Contract #: 04-0120F4Cty: SF/ALA Rte: 80 PM: 13.2/13.9File #: 69.25B**QUALITY ASSURANCE -- NON-CONFORMANCE REPORT****Location:** Changxing Island, Shanghai, PRC**Report No:** NCR-000251**Prime Contractor:** American Bridge/Fluor Enterprises, a JV**Date:** 13-Apr-2009**Submitting Contractor:** Zhenhua Port Machinery Company, Ltd (ZPMC), Changxing Island**NCR #:** ZPMC-0225**Type of problem:****Welding****Concrete****Other****Welding****Curing****Procedural****Bridge No:** 34-0006**Joint fit-up****Coating****Other****Component:** North Shaft, Lift 3, Skin A**Procedural****Procedural****Description:** Longitudinal Stiffener A, LS3-6IN**Reference Description:** Excessive heat input during heat straightening for Longitudinal Stiffener LS3-6IN**Description of Non-Conformance:**

Subject: NCR No. ZPMC-0225

Reference Description: Heat Straightening / Excessive Heat Input / Tower North Shaft Lift 3 / Longitudinal Stiffener

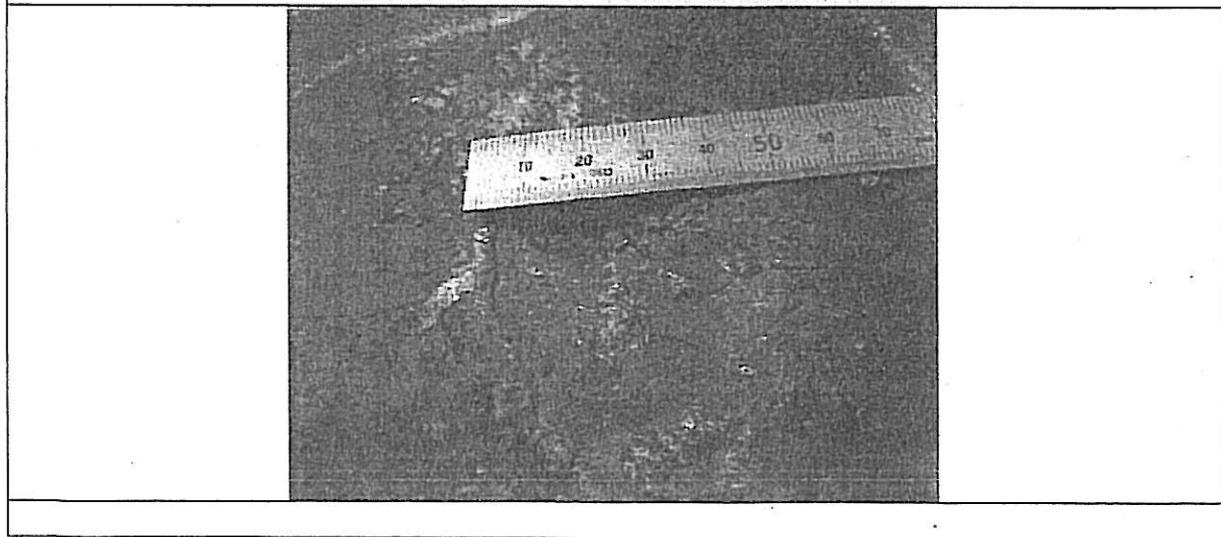
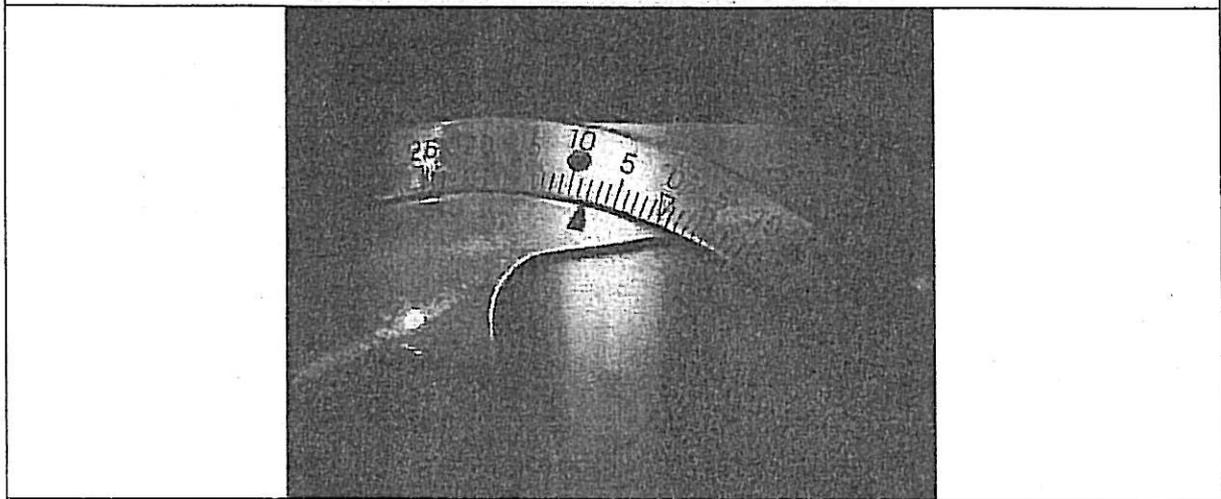
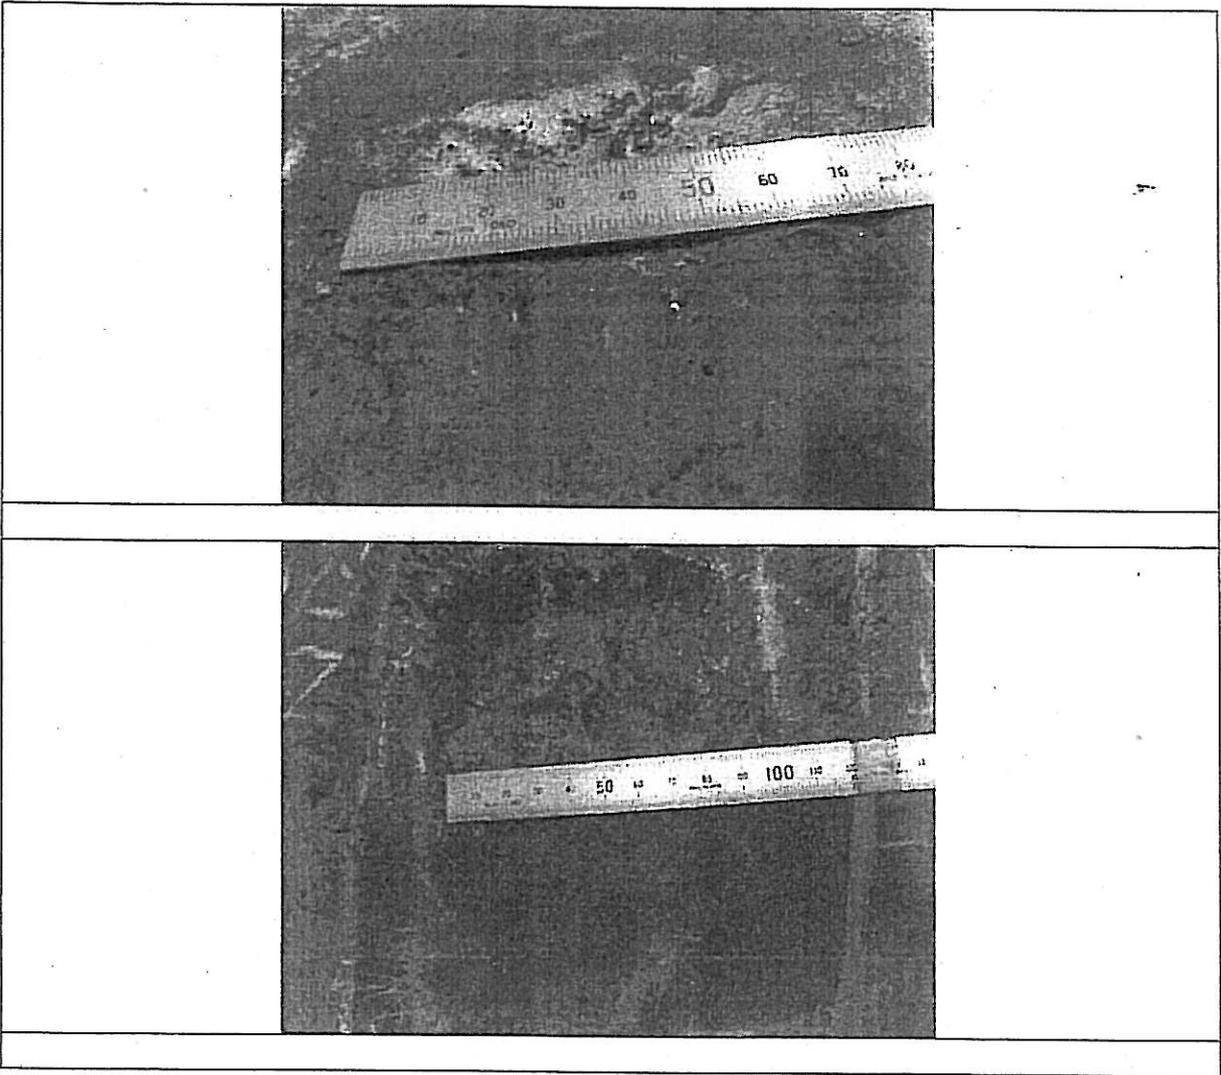
Description of Non-Conformance
 The surface was melted due to overheating during the heat straightening process on lift 3 NSD1-Skin A stiffener A3

Disposition:
 Hardness test to the damaged area and weld repair.

Proposal to prevent re-occurrence:
 During the heat straightening process, ZPMC QC have to monitoring and check the temperature.

产品名称: 美国海湾大桥 工程编号: ZP06-787
 Project Name: 美国海湾大桥 Project No.: ZP06-787
 构件名称: 北塔第三吊段 A 面板 构件图号: LS3-6
 Component Name: 北塔第三吊段 A 面板 Drawing No.: LS3-6
 生产部门: 胡震施工队 生产部门负责人签字: 陆叶飞
 Fabrication Dept.: 胡震施工队 Fabrication Manager: 陆叶飞

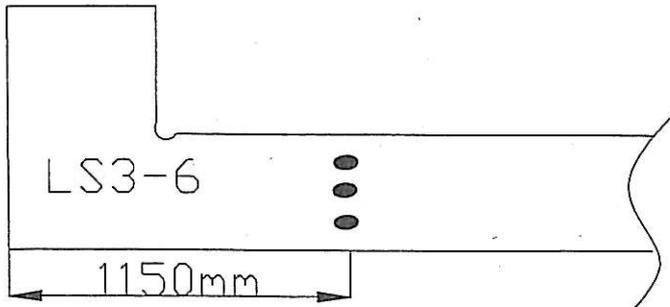
北塔第三吊段, A 面板 A3 纵向筋, LS3-6 校火过烧。具体如图:

将 LS3-6 端部切除, 增加焊缝, 焊缝位置图打在 1700 处
 Cutting off the melting metal area for about 1700mm length, replace it with a part.
 请提交 ABF 确认。 焊缝的厚度为 WT208 距端部
